Re: In the Matter of Domestic Septage Registration No. 710921
Childress Outhouses, LLC and Robert Lee Childress
(2465-1)

MOTION TO OVERTURN

Re: Request for Motion to Overturn Information
Childress Outhouses LLC
RN 710921

Map 1: Applicant's property is below RR track, to right of road, and slopes SW to existing quarry.(at top, right of photo).

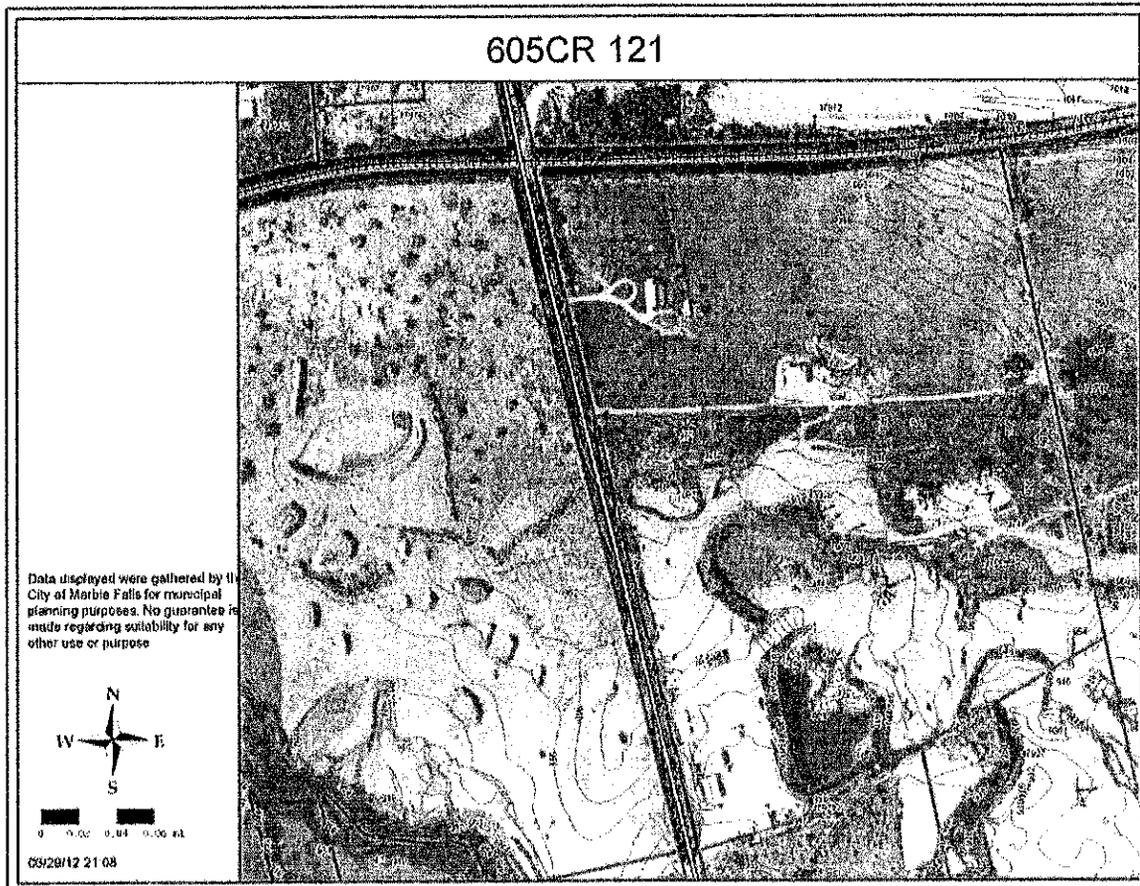
Secondly, there is an obvious water table, that is exposed, immediately downslope of Mr. Childress property (and even on the west side of CR 121). With the lack of utilization of BMP's, as well existing topography leading directly to the aforementioned aquifer, the likelihood of possible direct runoff contamination into the aquifer is extremely high. The observance of a "perched" water table, as evidenced by the spring on the neighbor's property, is cause for concern, as such existing conditions are not allowed under the Regulated Management conditions of the permit (as issued), and the permeability rates of the *in-situ* soils would have rendered such a site as unsuitable for land application of septage.
